CITY PLANNING COMMISSION

APPLICANT	Ferrar Williams Architects, 1418 20th Street, Sac, CA 95814				
OWNER	Harold Nielsen, 320 North 10th Street, Sacramento, CA 95813				
PLANS BY	Applicant				
FILING DATE	10/31/86	ENVIR. DET.	Neg. Dec 11-24-86	REPORT BY	JP/vf
ASSESSOR'S-PCL. NO.	274-320-38

- APPLICATION:**
- A. Negative Declaration
 - B. Special Permit to develop a 23,000+ square foot research/development facility
 - C. Variance to reduce the required 50 foot building setback to 36+ feet

PROPOSAL: The applicant is requesting the necessary entitlements to construct a 23,000+ square foot building for research and development uses in the Gateway Center PUD

Job No. 88-111
 Scale: 1/8" = 1'-0"
 Plat. North
 Sheet Title
ILLUSTRATIVE SITE PLAN
ROOT PLAN

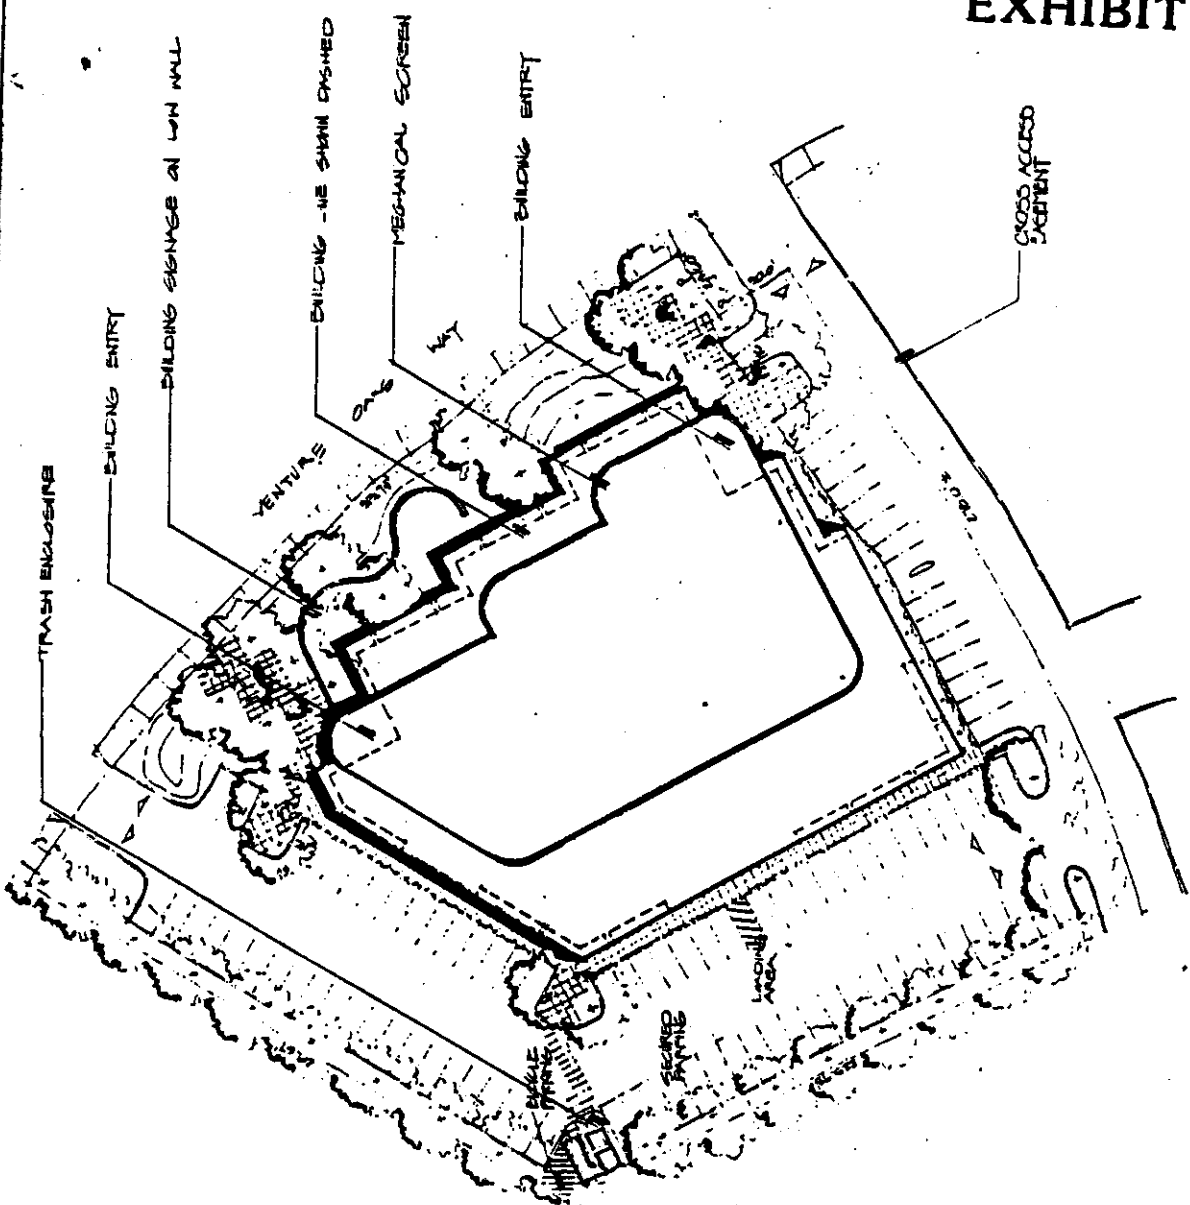
The applicant has designed the site so that all of the on-site parking is to the rear of the building with a 36+ to 43+ foot wide bermed landscaped setback in front of the proposed building along Venture Oaks Way. The City's MRD Ordinance requires a minimum 35 foot setback for buildings adjacent to public streets with right-of-ways of less than 100 feet; such as Venture Oaks Way; however, the PUD Guidelines indicate that the landscape setback on Venture Oaks Way is 25 feet and the building setback is 50 feet. The applicant is requesting a variance to the PUD Guidelines to reduce the building setback to 36 feet, similar to the MRD Ordinance requirement. Staff finds that the applicant's proposal allows for better parking and landscape design, add variety to the streetscape and should not be detrimental to adjacent properties as the proposed building is only one story in height. Staff has no objection to the variance request.

The site plan indicates a serpentine wall in a portion of the front landscape setback on which the company's name shall be indicated. Staff finds this proposed design element acceptable with the conditions that the wall be integrated into the berming subject to staff review and that the proposed sign meet all requirements of the PUD Guidelines.

The site plan also indicates bicycle parking, secured parking for company vehicles and a trash enclosure facility. These areas shall be enclosed and screened in accordance with the Gateway Center PUD Guidelines. Staff also recommends that the secured vehicle area be screened by a six foot high solid masonry wall compatible in design and materials to the main structure.

Seventy seven (77) parking spaces are required for the proposed MRD use. The site plan indicates 97 spaces. This number of vehicle spaces should be sufficient for the proposed MRD use.

1. Revised landscape, shading and irrigation plans shall be submitted for staff review and approval prior to issuance of building permits. Undulating berms in the front landscaped setback area shall be four feet. The landscape plans shall follow the approved PUD plant list.

2. The location and design of the proposed serpentine wall and any signage proposed for the wall shall be subject to Planning Director review and approval prior to issuance of building permits.

3. Outdoor secured vehicle storage area shall be completely enclosed with a six foot high solid masonry wall compatible in design and materials to the main structure. The plans for the storage area shall be subject to Planning Director review and approval prior to issuance of building permits.

Job No. 6777
Scale 1/8" = 1'-0"
Ref. North
Sheet Title
**SCHEMATIC
EXTERIOR
ELEVATIONS**

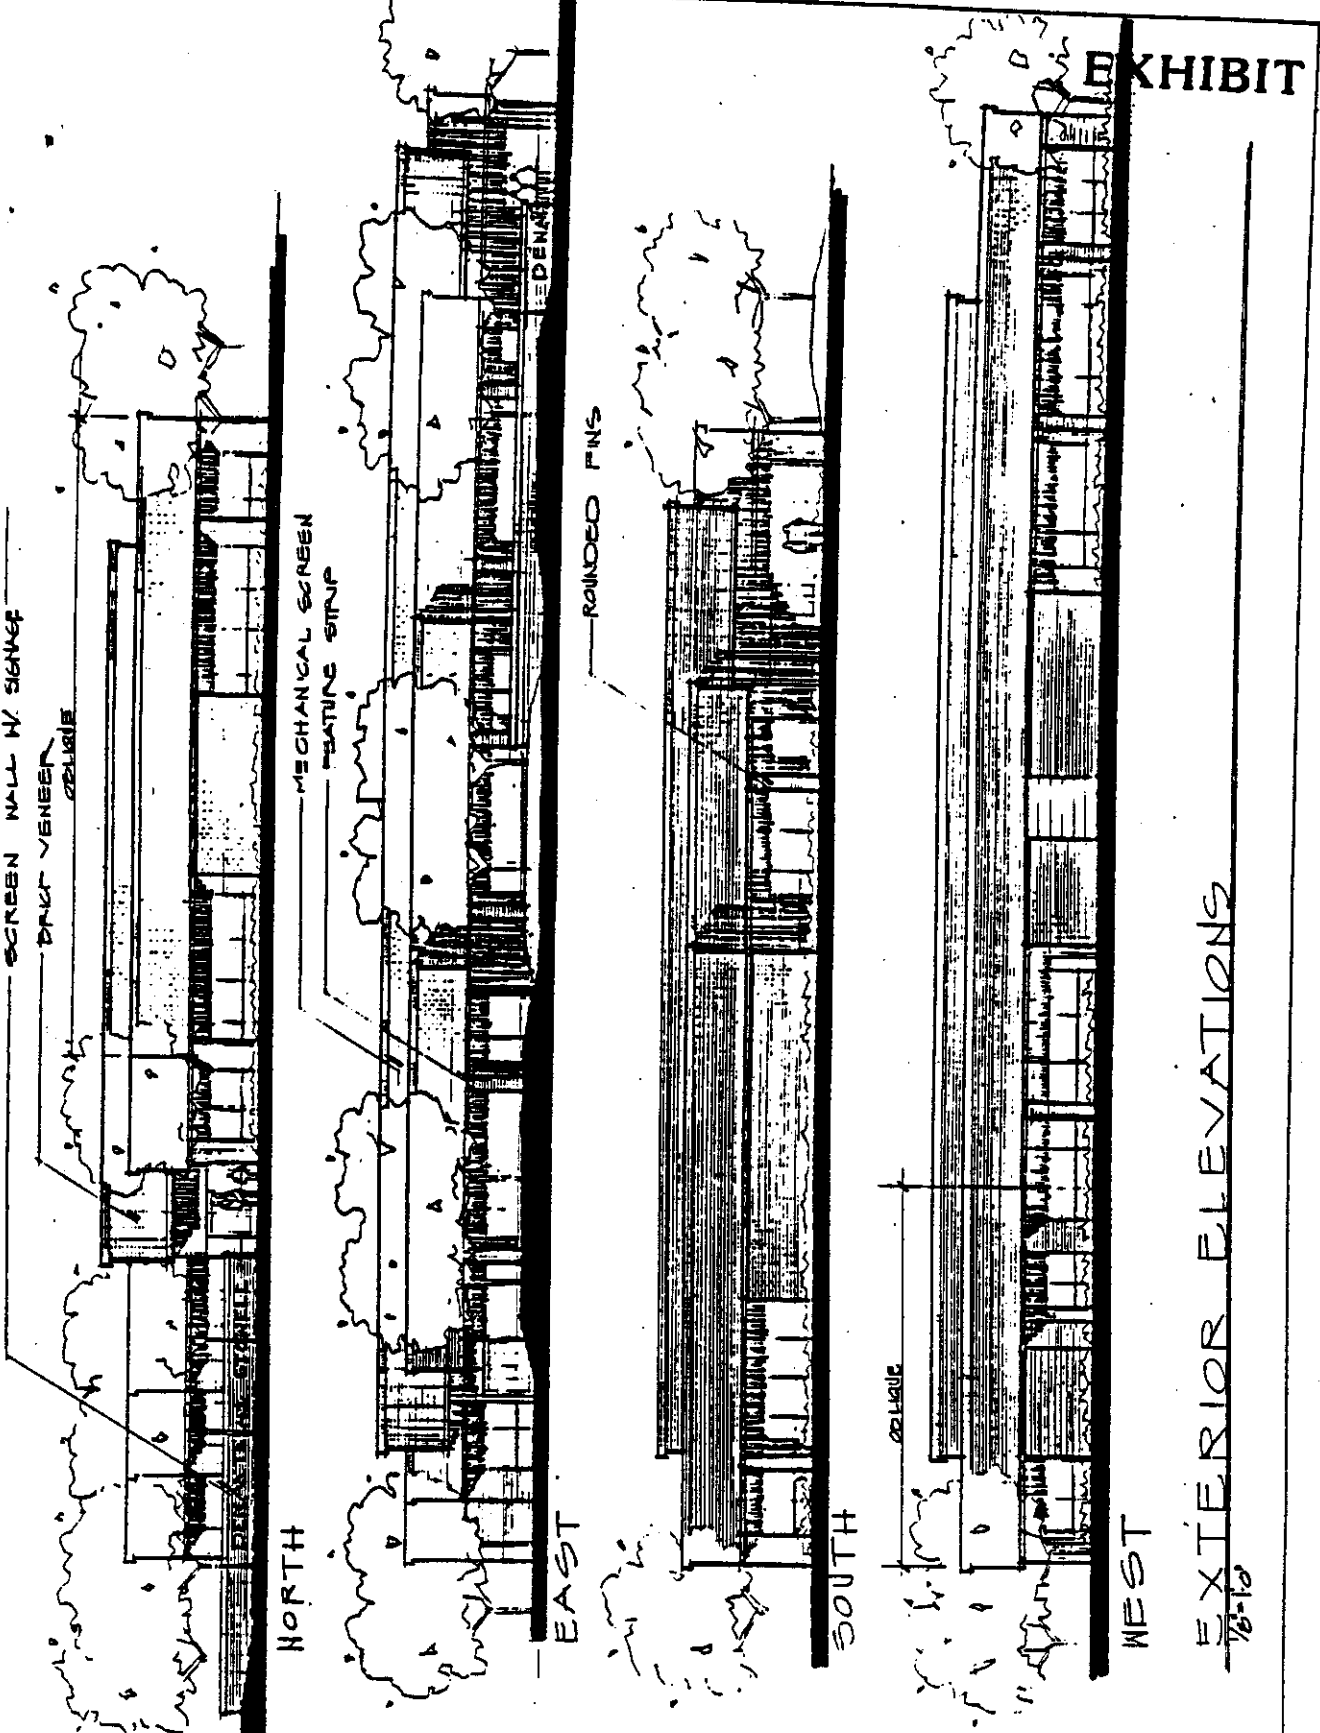
The applicant proposes to construct a one story structure with a stepped back building frontage. Several of the structure's corners are rounded instead of square, adding variety to the building exterior. Proposed materials are brick veneer and glass. Staff finds that the proposed building will be compatible with future buildings in the MRD area.

The Gateway Center PUD Guidelines require that all projects proposed for the MRD area are subject to the review and approval of the City's Design Review/Preservation Board. The applicant's proposal is subject to this requirement.

4. The applicant/owner shall be subject to the requirements of the City's Trip Reduction Ordinance for minor development projects.
5. The project is subject to the review and approval of the City's Design Review/Preservation Board.
